CONSTRUCTION SUMMARY

381 - 2 - The Barossa 3 (38-3) Elev B

Extras at Time of Sale

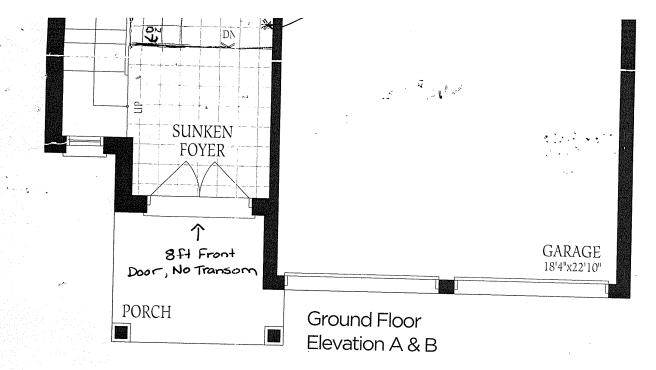
Arch to look like this
